Access Compliance Report Public Rights-of-Way (Curb Ramps)

Main Street: OLD_RANCH_RD Cross Street: LYNRIDGE_DR Location: SE

ADA ID: RPAT210921142044 Ramp Type: Type 3 - Combination 1 Initial Pass/Fail: Fail Overall Compliance: No Severity Score: 30

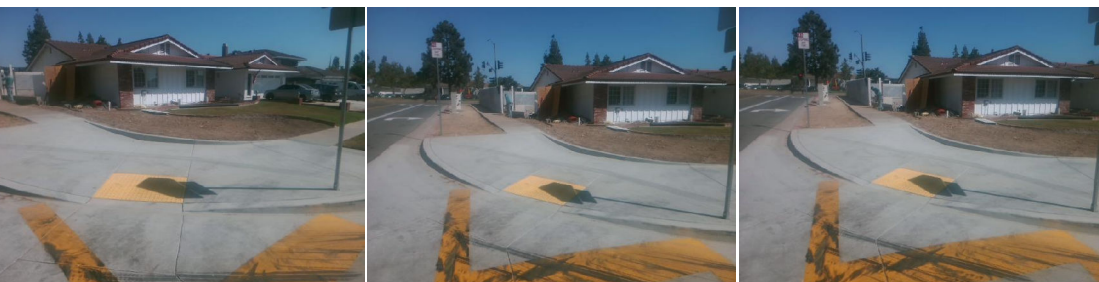
R304.2.2, R304.5.3, R304.3.2, STD 1115

Remove & Replace Curb Ramp With Two New Directional Ramps or Equivalent.
